DRAWING NUMBER **602SA** ISSUE **2a**

SOUNDCRAFT REF: ED5513-02

TITLE: ACTIVE SPLITTER POWER SUPPLY

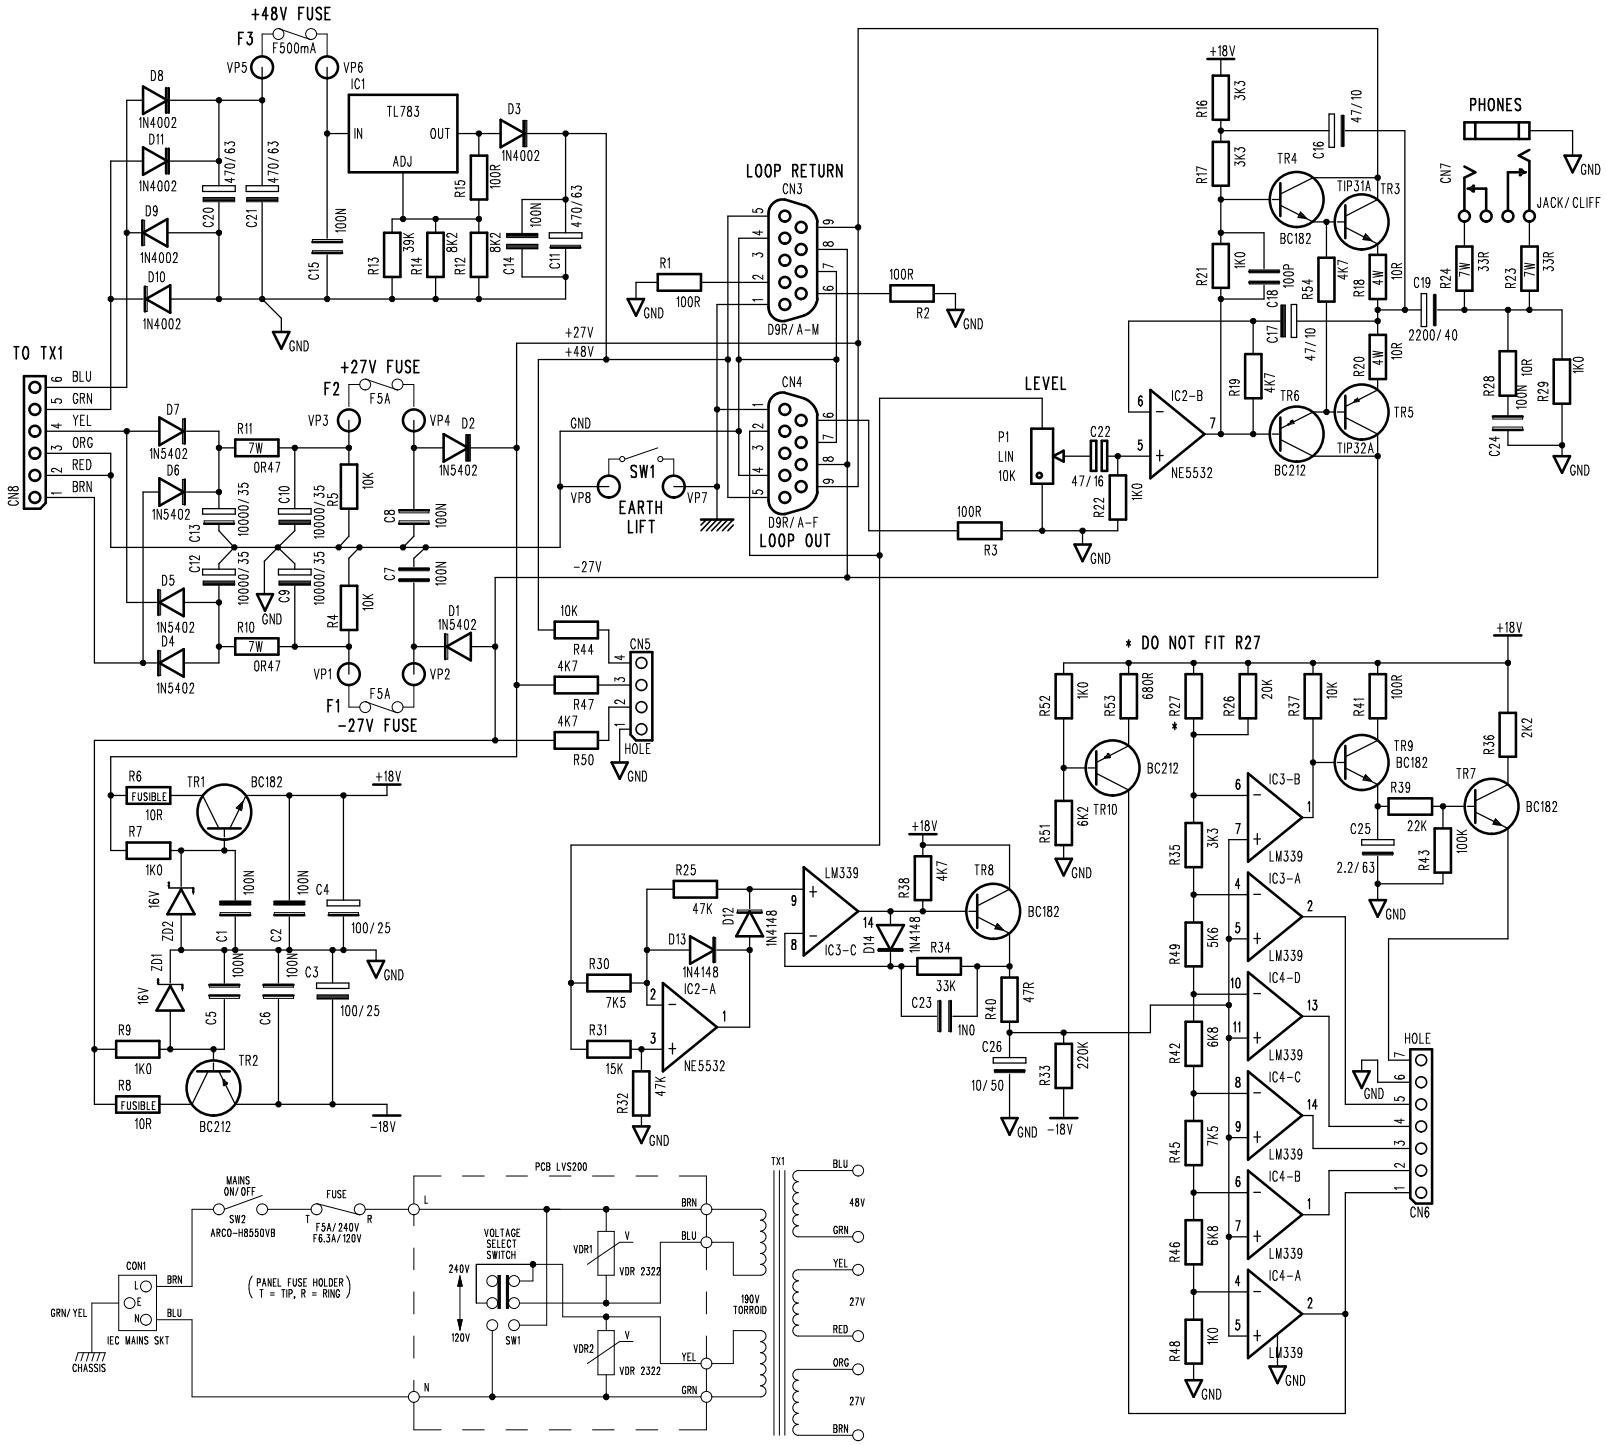
ISSUE DETAILS
2a. ECN6013 ZD1 & ZD2 WAS 20V
R26 WAS 180K. R27 NOW NOT FITTED
